Access Compliance Report Public Rights-of-Way (Curb Ramps)

Main Street: SCARLET_MAPLE_DR		Cross Street: SMOKE_TREE_DR		Location:	SW
ADA ID: RPAT211102152812	Ramp Type: Type 4 - Parallel	Initial Pass/Fail: Fail	Overall Compliance: No	Severity Score:	32

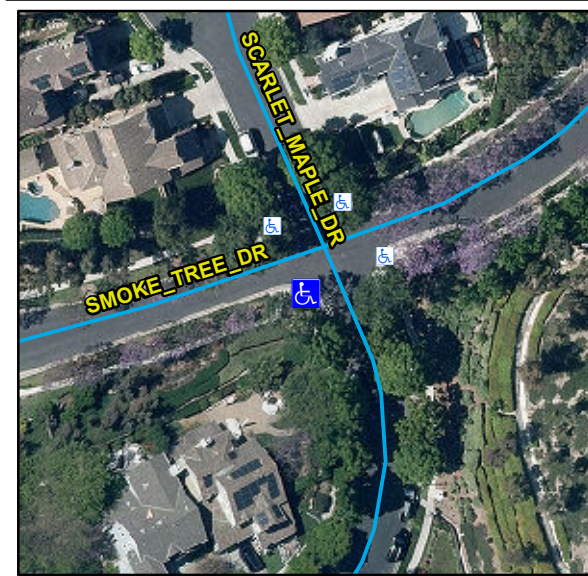
Compliance	Description	Data	Compliance	Description	Data
N/A	Ramp Length LT (in)	105	N/A	Ramp Length RT (in)	95
Yes	Ramp Width LT (in)	53	Yes	Ramp Width RT (in)	53
No	Ramp Run Slope LT (%)	13.1	Yes	Ramp Run Slope RT (%)	2.3
No	Ramp Cross Slope LT (%)	2.2	Yes	Ramp Cross Slope RT (%)	0.1
N/A	Landing Present	N/A	N/A	DWS Provided	N/A
N/A	Landing Length (in)	N/A	N/A	DWS Contrast	N/A
N/A	Landing Width (in)	N/A	N/A	DWS Length (in)	N/A
N/A	Landing Run Slope (%)	N/A	N/A	DWS Full Width	N/A
N/A	Landing Cross Slope (%)	N/A		DWS Offset Type	N/A
N/A	Landing Movement Obstructed?	N/A	N/A	DWS Offset Left (in)	N/A
	Landing Movement Type	N/A	N/A	DWS Offset Right (in)	N/A
N/A	Landing Shared	N/A			
N/A	Clear Space	Yes			
N/A	Clear Space To Crosswalk (in)	N/A			
N/A	Marked Crosswalk 1	No	N/A	Marked Crosswalk 2	No
	Crossing 1 Direction	E		Crossing 2 Direction	N
	Marked Crosswalk 1 Width (in)	N/A		Marked Crosswalk 2 Width (in)	N/A

N/A	Ramp Inside Crosswalk 1	N/A	N/A	Ramp Inside Crosswalk 2	N/A
	Crossing 1 Slope (%)	10.4		Crossing 2 Slope (%)	3.9
	Crossing 1 Cross Slope (%)	1.7		Crossing 2 Cross Slope (%)	7.5
N/A	Gutter Ponding	N/A	N/A	Curb Slope	5.3
Yes	Gutter Lip Height (in)	0		Road Run Slope (%)	7.6
N/A	Gutter Run Slope (%)	N/A		Road Cross Slope (%)	7.4
N/A	Gutter Cross Slope (%)	N/A	No	Perpendicular Joint Present	No
Yes	Overall Surface Condition	Acceptable			
	Cross Gutter Present?	No		Spandrel Present?	No
	Replace Cross Gutter?	N/A		Replace Spandrel?	N/A

Remove & Replace Curb Ramp With Two New Directional Ramps or Equivalent.
